PRODUCT INFORMATION

Product Bulletin No.: 81745999 Rev. 0

Subject: HP Fluid Filtration Unit now available as a part of NOV drilling packages.

Product Model: NOV N-Line Tensioner Systems: NRT-1800, NRT-3600 and NRT-4200

Prototype of Fluid Filtration Unit

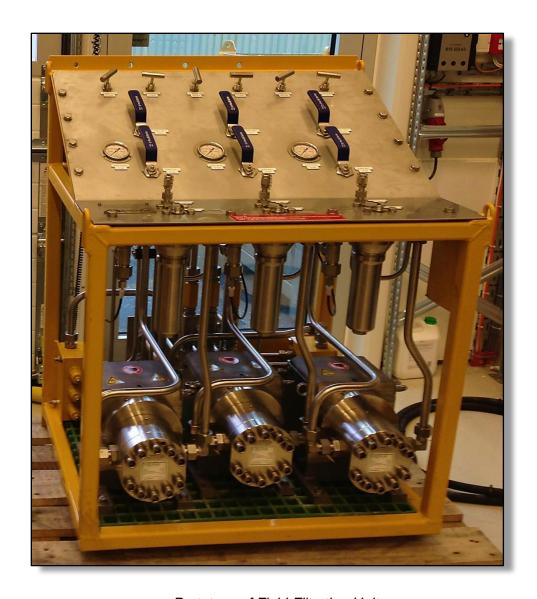
Issue: Keeping hydraulic fluid clean has always been a major concern for rig-

operators worldwide. It has been shown several times how fluid particle contamination can drop life expectancy on seals, gaskets, wear bands and cylinders. All NOV hydraulic equipment are delivered with cleanliness class ISO 4406:99 17/15/12 (NAS 6) and cleanliness during operation should not drop below ISO 4406:99 19/17/14 (NAS 8). Experience has shown that this requirement is hard to obtain and in many situations today the equipment must be shut down in order to perform a full particle filtration of the hydraulic fluid. This is not only time consuming, but also dramatically reduces the

number of operating days, with subsequent loss of profit.

Solution: NOV has designed a solution for filtering hydraulic fluid that does not require

shutdown of any components as the filtering is done continuously inside the high pressure loop. Installing this fluid filtration unit will reduce downtime because of maintenance. Also the hydraulic fluid will be less prone to particle

contamination, thus reducing the risk of equipment malfunction.
